SUBJECT: Provides final piping & restraint stresses as compared to stress allowables & explanation of why proposed mod required two rupture disc/baffleplate assemblies rather than one, per NRC request re NUREG-0737, Item II.D.1. Tables & figures encl.

Docket 50-305  
Operating License DPR-43  
Kewaunee Nuclear Power Plant  
TAC #44590  
NUREG-0737, Item II.D.1 "Performance Testing of Relief and Safety Valves"  
Request for Additional Information

S/RV Discharge Piping Double Rupture Disc/Baffleplate Assembly

FIGURE -1: "PLAN VIEW OF KEWAUNEE RUPTURE DISC/BAFFLEPLATE ASSEMBLY  
"CONFIGURATION"  
(Figure A23-1, Reference 2)

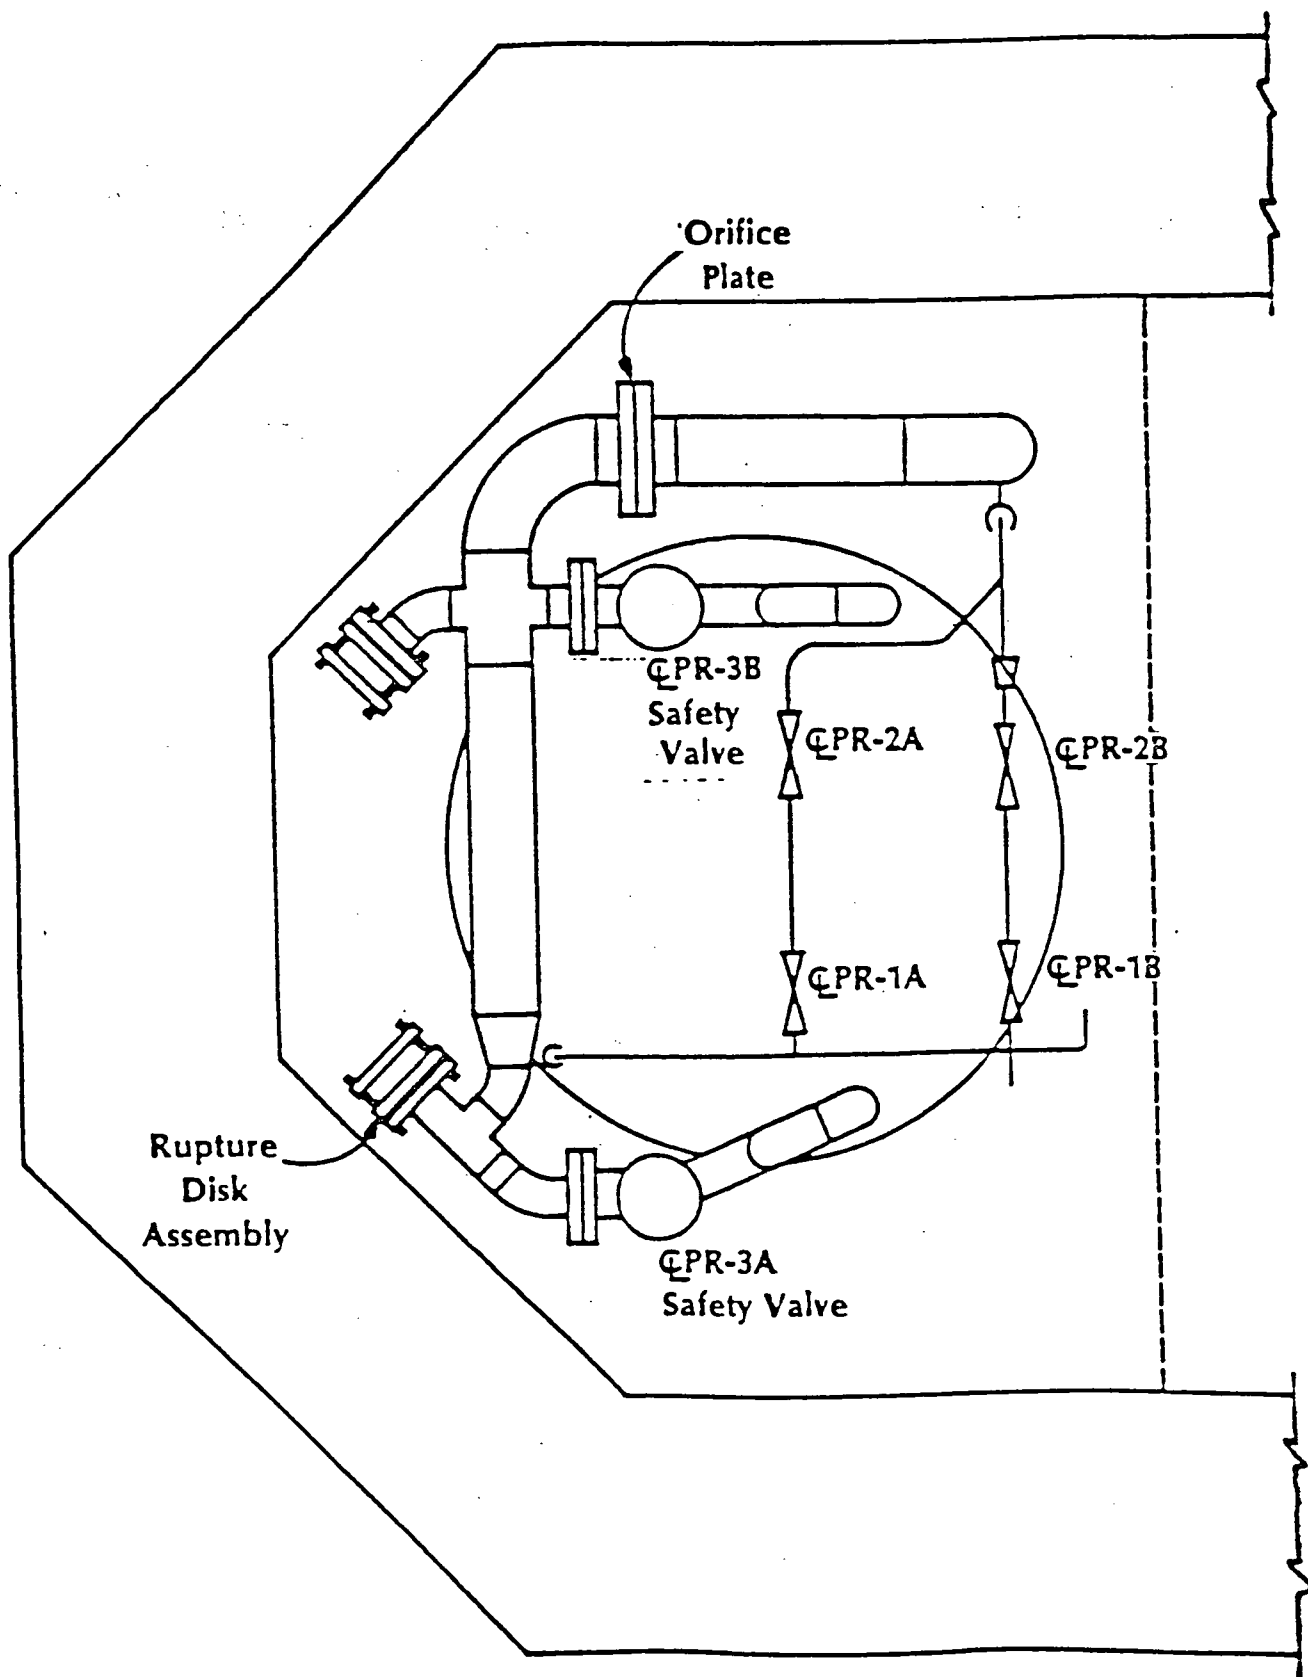
- 1) Due to space limitations inside the pressurizer vault, the rupture disc/baffleplate assembly(s) had to be installed at a 45 degree angle to the discharge of the safety valve(s) rather than in line with the discharge (Figure 1). This increased peak loads over those from the previous analyses which assumed an inline configuration.
- 2) With only one rupture disc/baffleplate assembly installed (PR-3A), part of the discharge flow from safety valve PR-3B would merge with the discharge flow from safety valve PR-3A resulting in a water hammer effect. The resulting pressure spikes caused additional peak loads at high frequencies in the discharge piping.

To reduce these effects, two rupture disc/baffleplate assemblies will be installed; one at the discharge of each safety valve (PR-3A and PR-3B). Both rupture disc/baffleplate assemblies will be orientated at a 45 degree angle to the discharge of the safety valves in the same plane but opposite directions (Figure 1). In addition, a 10-inch piping segment will replace the 6-inch piping run between the first 90 degree elbow at the discharge of safety valve PR-3A and the as-built 10-inch by 6-inch reducer. This was necessary to decrease the pressure spikes caused by a two-safety valve actuation (Figures 2a and 2b).

FIGURE-3: "PIPING ISOMETRIC OF THE KEWAUNEE S/RV DISCHARGE PIPING FROM SAFETY VALVES TO FIRST VERTICAL 10-INCH ELBOW"

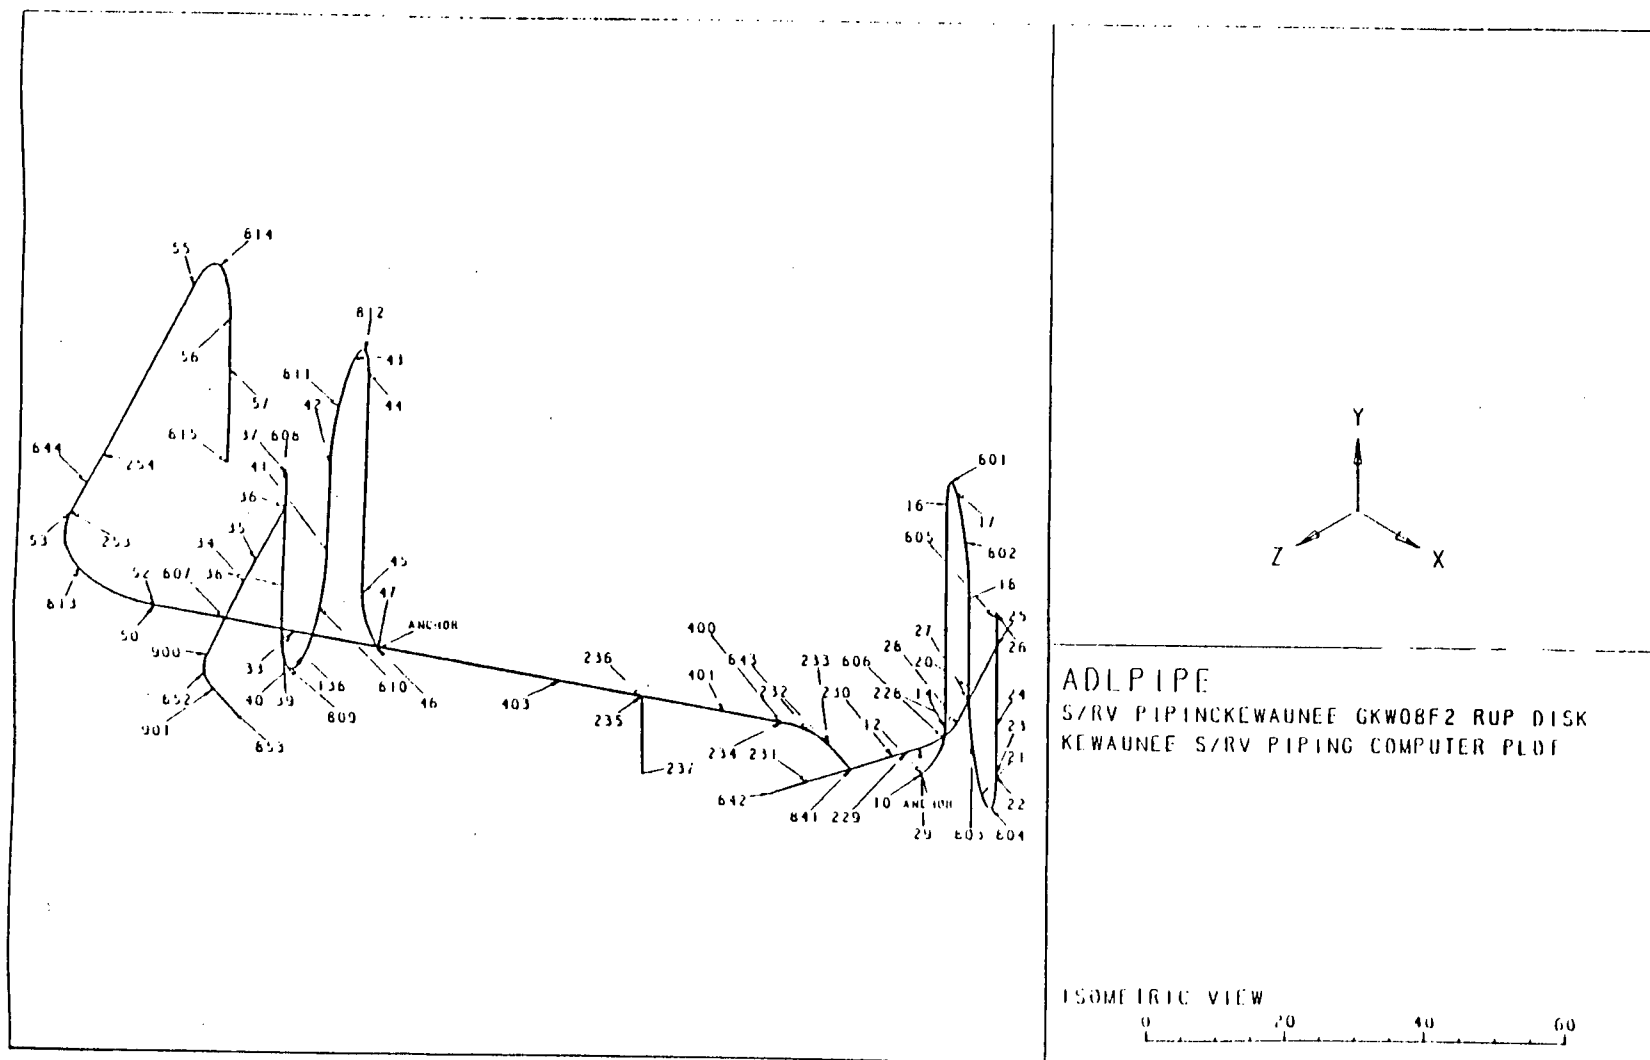
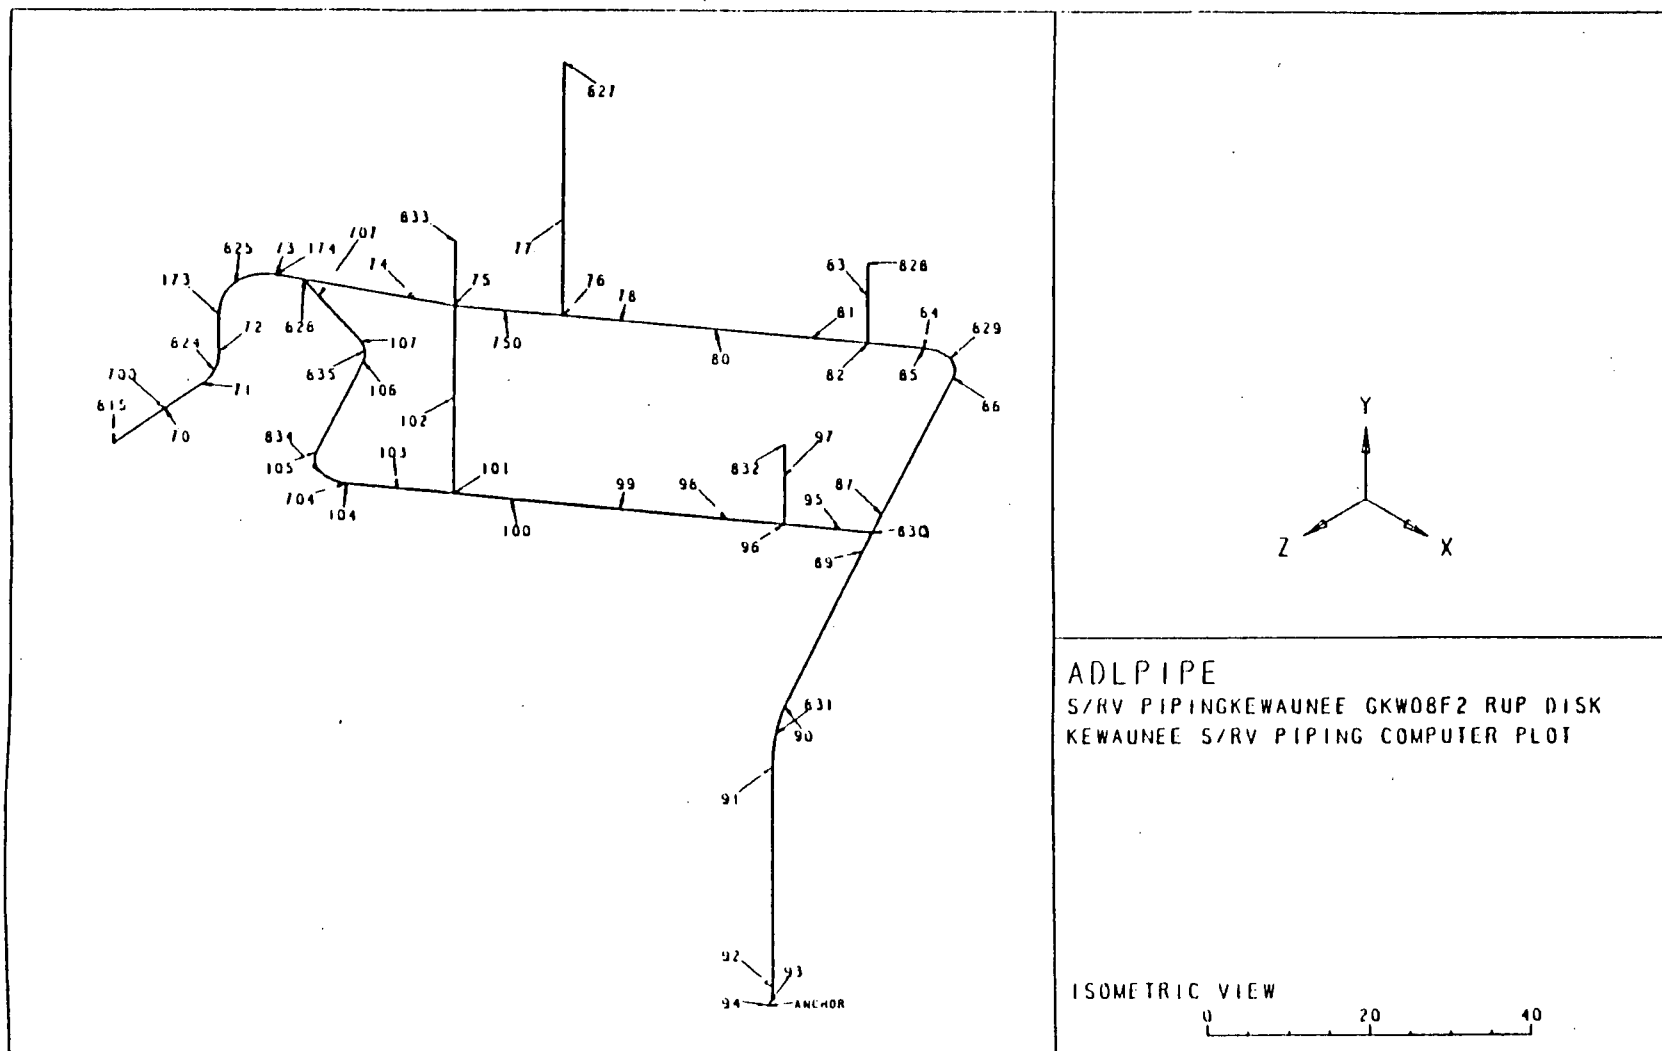
The ADLPIPE computer code calculated the piping stresses and provided the restraint loadings (static, seismic and dynamic time-dependent). Figures 3, 4, and 5 in the attachment to this letter provide piping isometrics for the S/RV discharge piping, from the pressurizer to the pressurizer relief tank, which show the ADLPIPE node numbers and anchor points.

Tables 4 and 5 in the attachment to this letter provide the maximum stress values calculated in the S/RV discharge piping, for the thermal range, normal, upset and faulted conditions, and a comparison to the stress allowables. The locations of these maximum stresses are identified by ADLPIPE node numbers which can be located on the piping isometrics in Figures 3, 4, and 5. All piping, both upstream and downstream of the S/RV's, has been evaluated according to the load combinations for Class I piping and components. In all cases, the resultant stresses are within the stress allowables.
